LEUPA

Type B(U) Package for Fissile Materials

**INDEPENDENT REVIEW OF DOCUMENT
0908-LE01-3BEIN-024-B: LEUPA –
CRITICALITY ANALYSIS**

December 12, 2012

Figure 2: Vertical and horizontal section of LEUPA package in the SCALE model

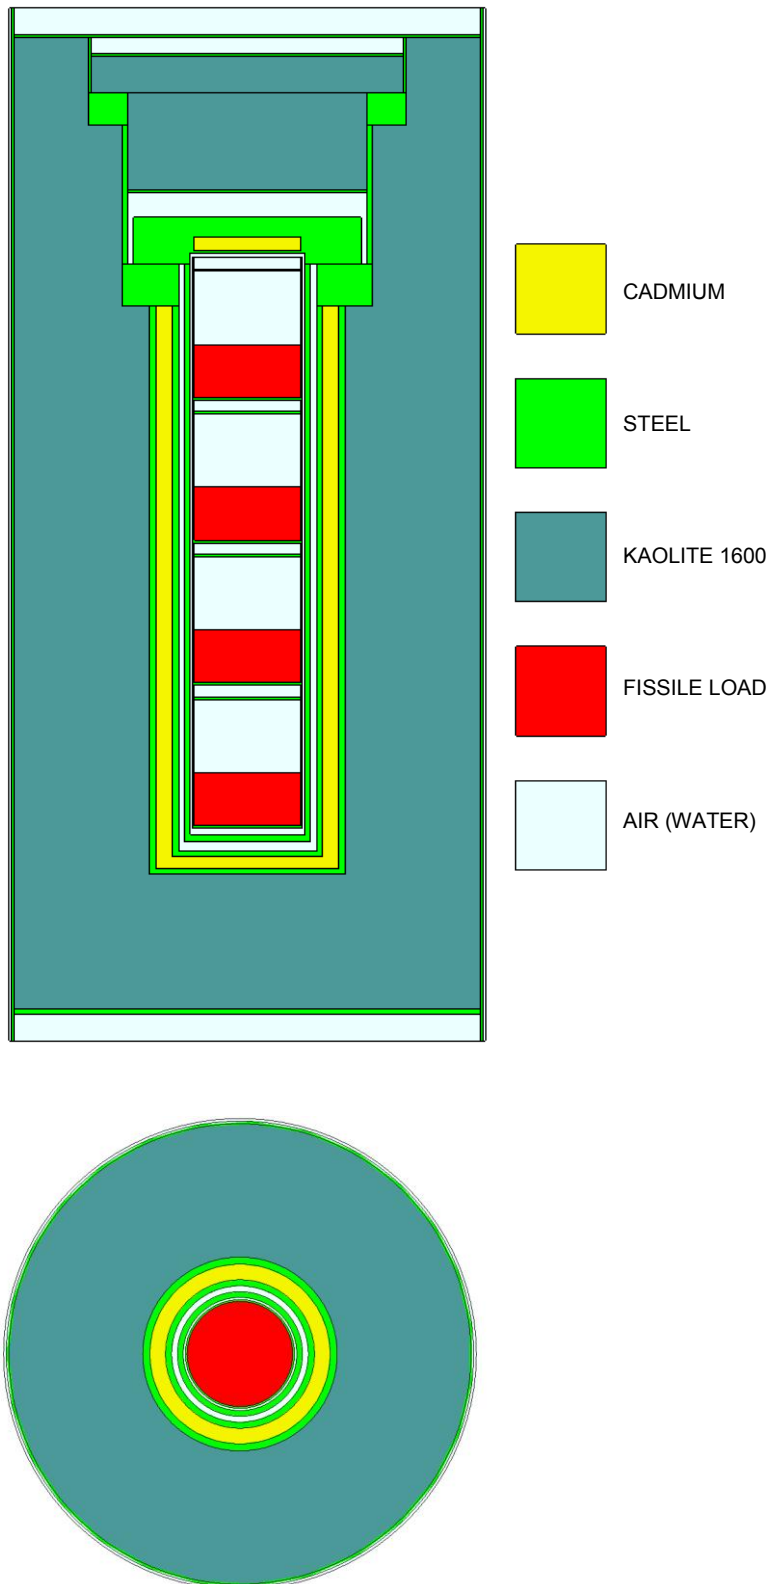
7. A horizontal section and a vertical section of the LEUPA package are displayed on Figure 2: for the purposes of showing the detail of the geometry modeled in KENO-VI.

8. The most significant measurements of the package (volume of the primary container, thickness of the cadmium absorbent, external measurements of the package) were modeled according to the reference drawing [3]. The geometry of the confinement system cover, intermediate removable cover and external cover was simplified, maintaining the nominal thicknesses and allowing the existence of gaps that can be filled with water when accidental situations are analyzed.

9. Unlike the MCNP model described in reference document [2], in the SCALE model the fissile material does not fill the entire container. Given the real density of uranium metal and the nominal mass transported by each container, only half of the container is full, as we can see in Figure 2:. In [2], a fictitious density was used in order to fill the container while keeping the nominal mass. Both models are, *a priori*, equivalent.

7. Given this result, and because the cadmium chamber does not fully cover the container - the cadmium chamber is interrupted in the area of the flange of the container cap, Figure 1: and Figure 2: -, it is also relevant to assess the effect of a potential inversion of the package (i.e., if, for any reason, the package rested on the cover instead of the base). Thus, the fissile load in one of the internal containers would be surrounded by less cadmium than the remaining containers, and it is therefore expected that the reactivity of the system in this situation will be higher. The result of this simulation is as follows:

Figure 3: Horizontal section of the square arrangement of 5*N LEUPA packages, reflected by 30 cm of water

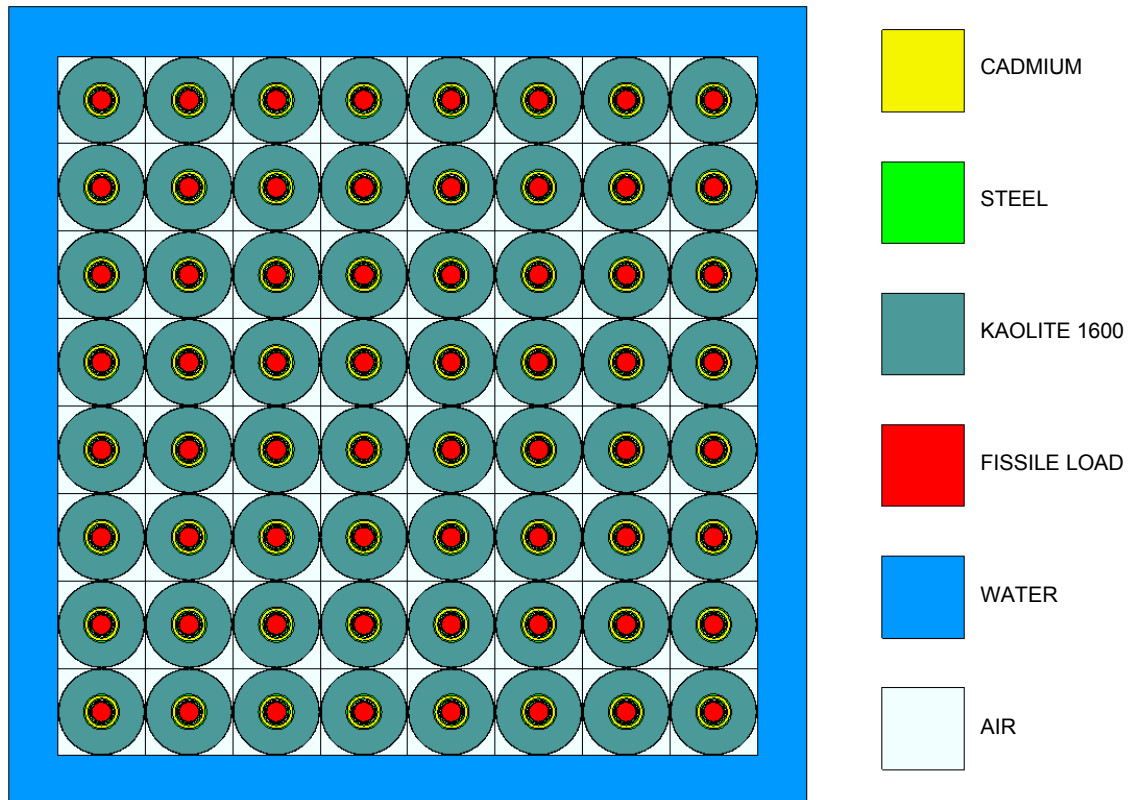
1. The multiplication factor (k_{ef}) for fivefold “N” packages (384 in this specific case), without the presence of water, and with the geometry modeled as described in reference document [2] (MCNP) and section 7.2 (SCALE) is as follows (Figure 3:):

$k_{ef} + 3\sigma (\sigma < 0.0003) = 0.53898$ (SCALE) $k_{ef} + 3\sigma (\sigma < 0.0002) = 0.45798$ (MCNP [2])

2. Although both results indicate that the set of packages is subcritical by a wide margin, there are doubts as regards the reasons for the difference between the results obtained with MCNP and SCALE.
3. In order to understand those differences, two additional calculations were made:
 - a. With SCALE, where the fissile material fills the entire interior container (using a fictitious density for uranium in such a way as to fill all the interior container and keeping the nominal mass);
 - b. With MCNP, where the fissile material is modeled with its real density, so that the nominal mass fills the interior container only partially, as shown on Figure 2:.. This model was developed based on the model used to obtain the results reported in [2].
4. The set of multiplication factors obtained is as follows:

5. Therefore, differences in the value of k_{ef} calculated by both codes reduced to $\sim 0.02 \Delta k$, considering the differences in the chain of calculation (effective sections and calculation code), and taking into consideration the slight differences in the modeled geometry (empty spaces, detail of intermediate covers), the SCALE calculation confirms what was calculated with MCNP.

Figure 4: Horizontal section of the hexagonal arrangement of 5*N LEUPA packages, reflected by 30 cm (minimum) of water

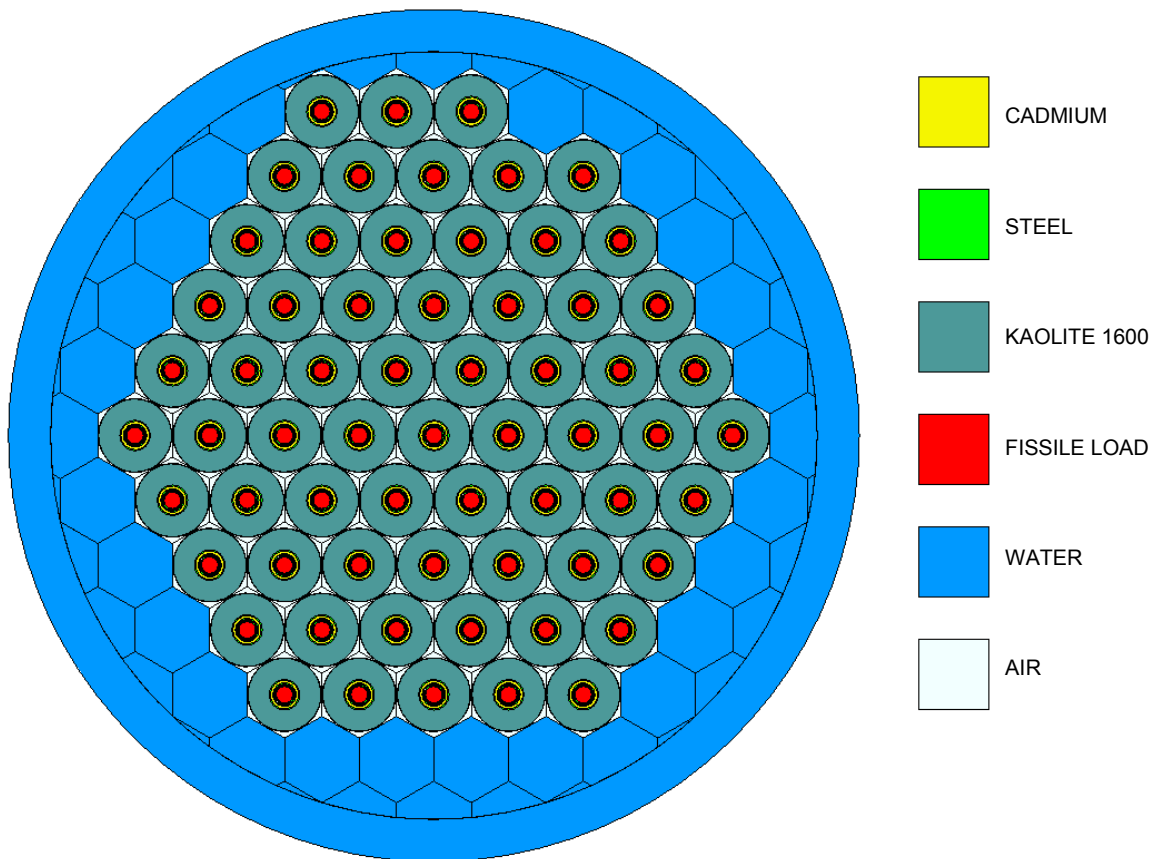
9. To evaluate the effect of assuming a different geometric arrangement of packages, a case in which packages are distributed in a hexagonal arrangement was simulated (Figure 4:), keeping the same 6 axial levels assumed on the square disposition. The result is as follows:

$$k_{\text{ef}} + 3\sigma (\sigma < 0.0003) = 0.53898 \text{ (SCALE – square disposition 8x8x6)}$$

$$k_{\text{ef}} + 3\sigma (\sigma < 0.0002) = 0.56330 \text{ (SCALE – hexagonal disposition)}$$

10. The hexagonal arrangement is therefore the most reactive scenario, given that it is the most compact arrangement among the possible regular arrangements. Any other random disposition of packages would be less compact than the hexagonal arrangement proposed, hence its lower reactivity. The modeled case is useful to prove the subcriticality of the system of 5*N packages, regardless of the disposition (vertical or not) of the packages.

Figure 5: Variation of the effective multiplication factor based on the mass of water retained in the Kaolite 1600

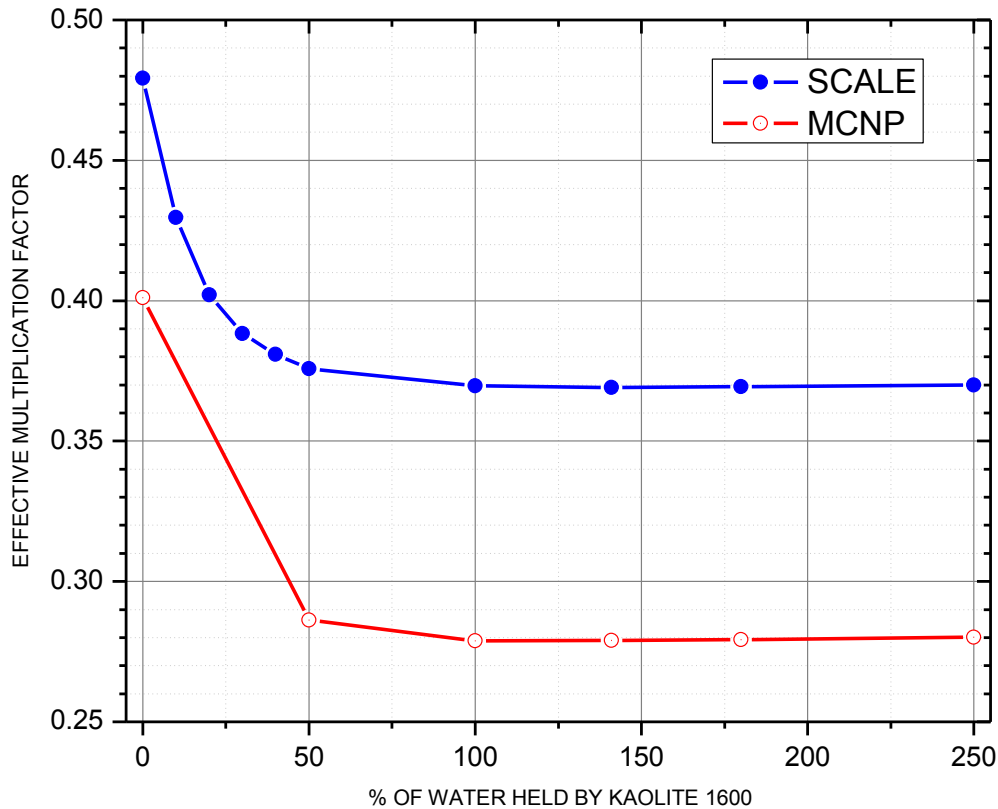
- Figure 5: contains a graph on the values of ($k_{ef} + 3\sigma$) obtained with MCNP and SCALE, based on the percentage of water retained by the insulation.
- The SCALE calculation confirms that the most unfavorable situation from the criticality standpoint is the case of dry heat insulation, as stated in [2].

Figure 6: Variation of the effective multiplication factor based on the density of water entering the empty spaces inside and outside the package

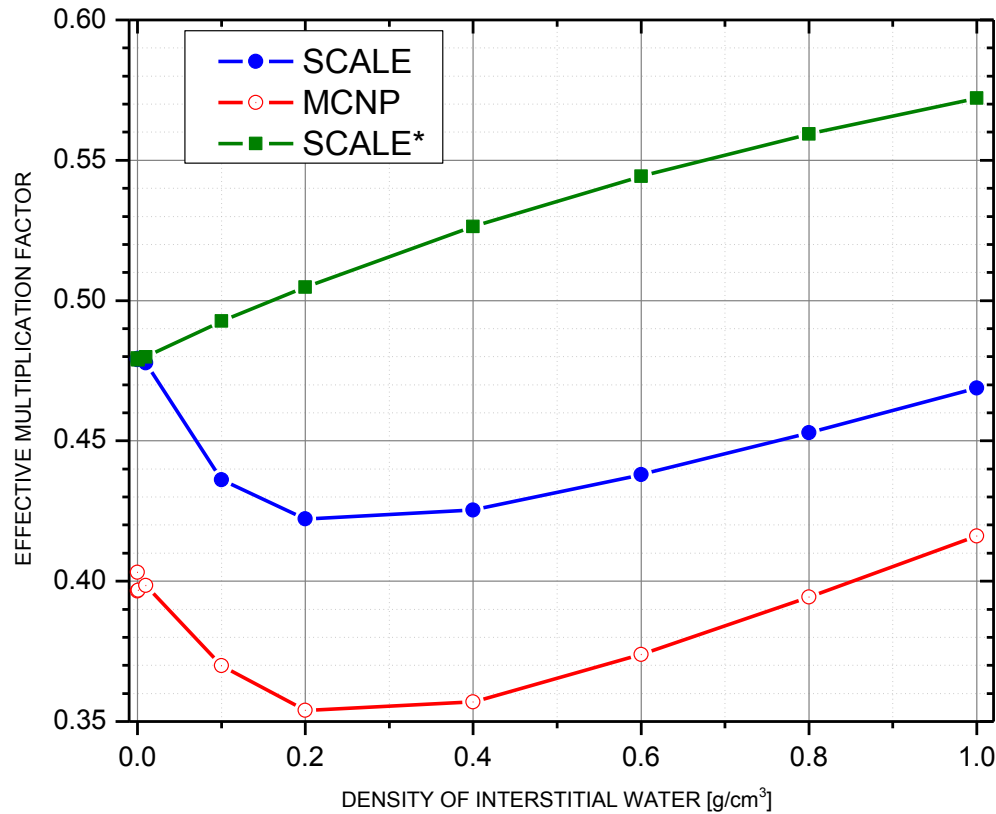
5. Figure 6: shows the values calculated with MCNP (red curve, empty circles) and SCALE (blue curve, solid circles). The existence of a minimum based on the density of the water entering the package suggests the presence of phenomena competing among them in relation to the reactivity of the system. In order to identify and separate these phenomena, another series of calculations was prepared, where the inflow of water to the package was

simulated, but only to empty spaces located within the confinement system. In other words, we simulate a scenario where there is water inflow only through empty spaces located on the inside of the cadmium cover. The results obtained are shown in the last 3 columns of Table 3:, under the heading “SCALE* (H₂O confinement only)”.

6. The curve indicated as “SCALE **” (green curve) in Figure 6: shows that the more reactive case is that where the water inflow only to the existing empty spaces inside the cadmium cover is simulated. This water provides moderation to the sub-moderate system and therefore the multiplication factor increases with the inflow of water.
7. On the contrary, when water is also added outside the cadmium cover, the additional moderation obtained does not translate into an increase of the effective multiplication factor of the system, since the thermalized neutrons in the area outside the cadmium cover are absorbed in the cadmium before re-entering the containers with fissile material.

Figure 7: Variation of the effective multiplication factor based on the mass of water entering each internal container

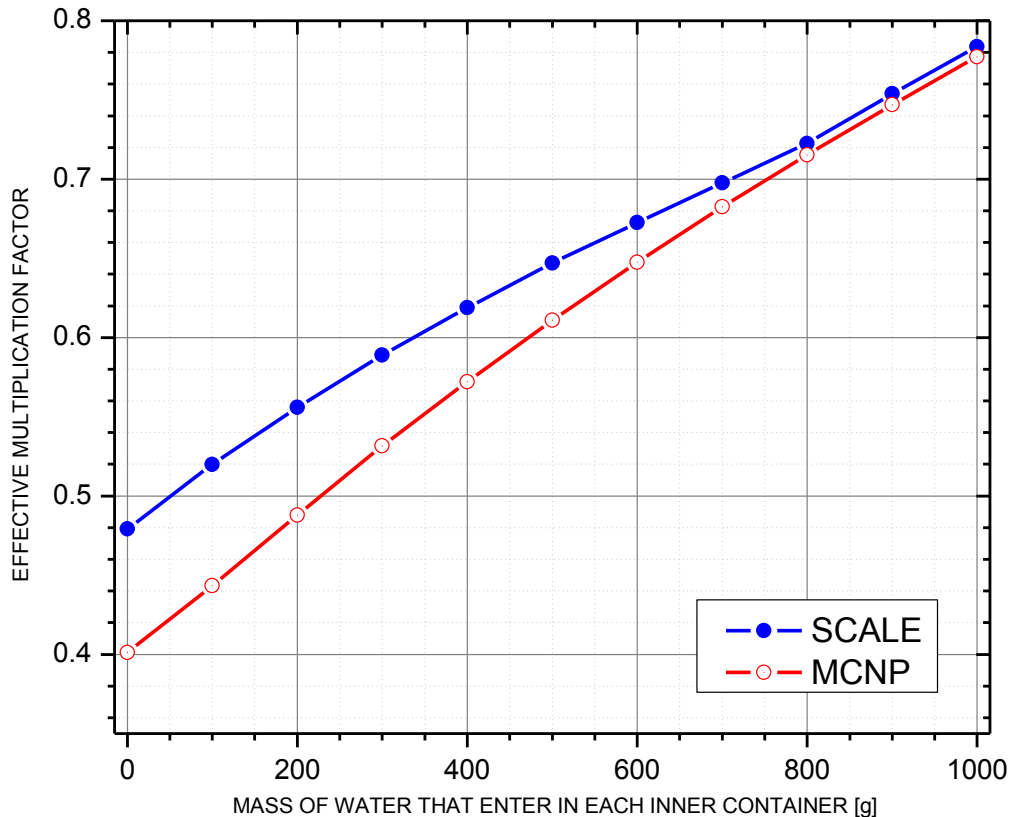
6. Figure 7: contains the calculated values.
7. We can see that the multiplication factor increases monotonously with the water mass entering the inside container. Be it reminded that, given the measurements of the internal containers and the nominal mass of uranium metal per container, it is not possible to add more than 900 g of water per internal container.
8. In all cases, the value calculated with SCALE is higher than the value calculated with MCNP. The difference between both calculations is reduced to a minimum as the mixture of water+uranium metal modeled in SCALE fills the free volume of each interior container, since the differences in the fissile volume modeled with both codes is reduced when water is added to the container. This behavior confirms what is stated in section 7.4.1, paragraphs 3 to 6.

Figure 8: Variation of the effective multiplication factor depending on the density of water entering the gaps in the packages arrangement, when the insulation is dry

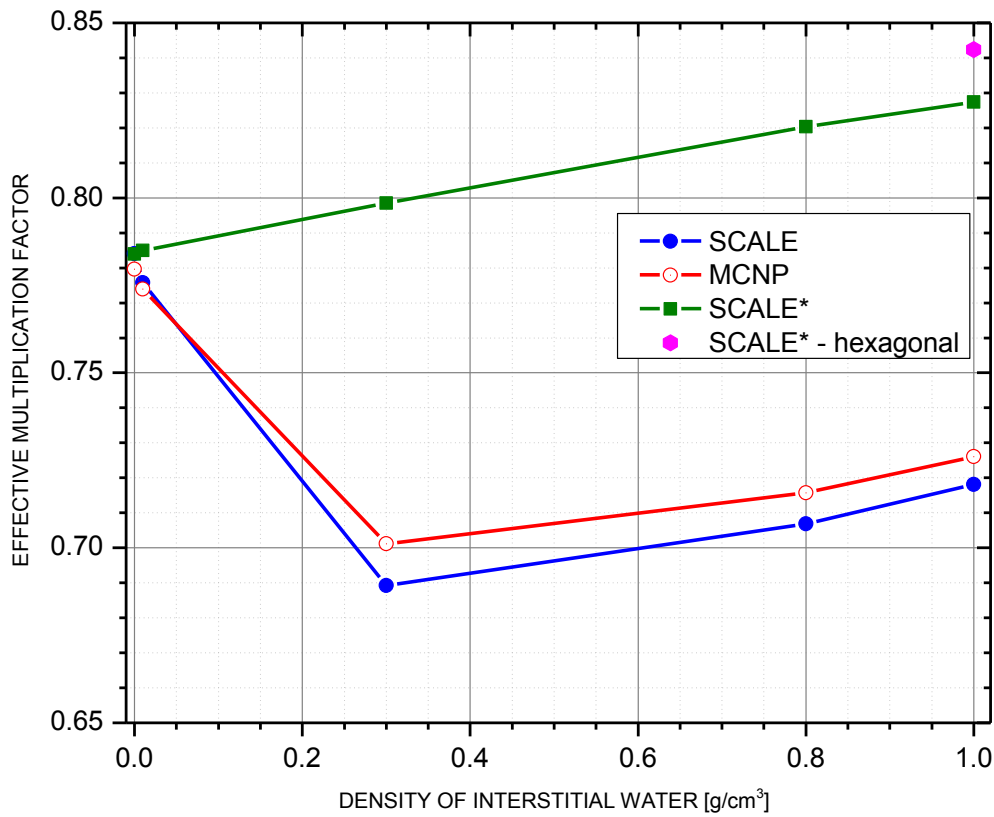
11. It is precisely in this group of cases calculated with SCALE where the more reactive case is identified: internal containers flooded with water (1000 g water per container), dry thermal insulation, and maximum density of water in empty spaces located inside the confinement.

12. Cases resulting in the maximum k_{ef} obtained with MCNP and SCALE are highlighted in Table 5:.
13. Figure 8: contains a graph of the results obtained with MCNP and SCALE, for cases where the insulation is dry, for different densities of water entering the gaps (homogeneous inflow of water in all the gaps of packages, and inflow of water only to the gaps located to the interior of the confinement, indicated with the label "SCALE *" in Figure 8:).

14. In all those cases, a square arrangement of packages was simulated in the system. Figure 8: also shows a calculation point that corresponds to the simulation of a hexagonal arrangement of packages in the system ($k_{ef} + 3\sigma = 0.84234$).

Figure 9: Multiplication factor depending on the density of the interstitial water, for different cases in which cadmium did not infiltrate into the cadmium chamber

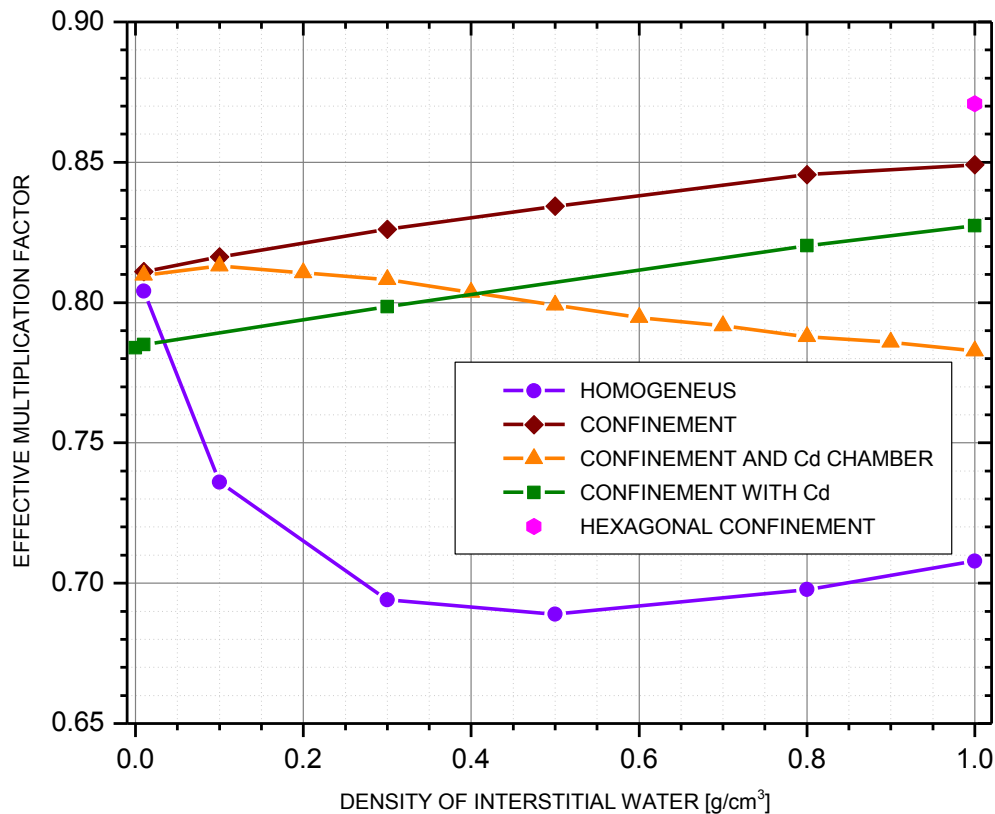
8. Thus, three groups of additional cases were calculated:
 - a. With inflow of water to all the empty spaces within the package and among the packages, marked with the tag “homogeneous” in Table 6: and Figure 9:.

- b. With inflow of water only to the empty spaces within the confinement system, marked with the tag “confinement” in Table 6: and Figure 9:.
 - c. With inflow of water only to the empty spaces within the confinement system and also the empty space in the cadmium chamber, marked with the tag “confinement and Cd chamber” in Table 6: and Figure 9:.

9. The curve displayed in Figure 8: is repeated in Figure 9: when water enters only the interior of the confinement (curve labeled as “confinement - with Cd”), for the sole purpose of making the effect of removing the cadmium from the cadmium cover visible.

10. In all those cases, a square arrangement of packages was simulated in the system. Figure 9: also shows a calculation point that corresponds to the simulation of a hexagonal arrangement of packages in the system ($k_{ef} + 3\sigma = 0.87083$).

11. It can be seen that, again, the worst case is the one in which internal containers are flooded with water (1000 g of water), the insulation is dry, water enters only into the gaps within the confinement, and the density of water in these empty spaces is equal to 1 g/cm^3 . This case, which yielded the highest effective multiplication factor of all those evaluated so far, shows that even under the hypothesis of this accidental case, the subcriticality of the packages system is assured with one sufficient margin.
